Access Compliance Report Public Rights-of-Way (Curb Ramps)

Intersection ID: N/A Main Street: AYRSLEY_TOWN_BV Cross Street: SESSIONS_ST Location: N

ADA ID: DE917478E2C1 Ramp Type: PerpDiag Initial Pass/Fail: Pass Overall Compliance: No Severity Score: 0

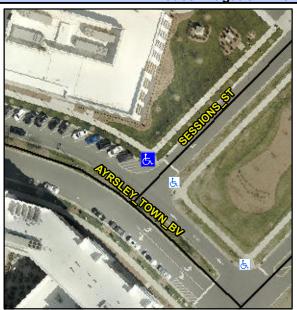
Possible Solutions:

Remove & Replace Detectable
Warning System.

PROW/ADA:

R305.2
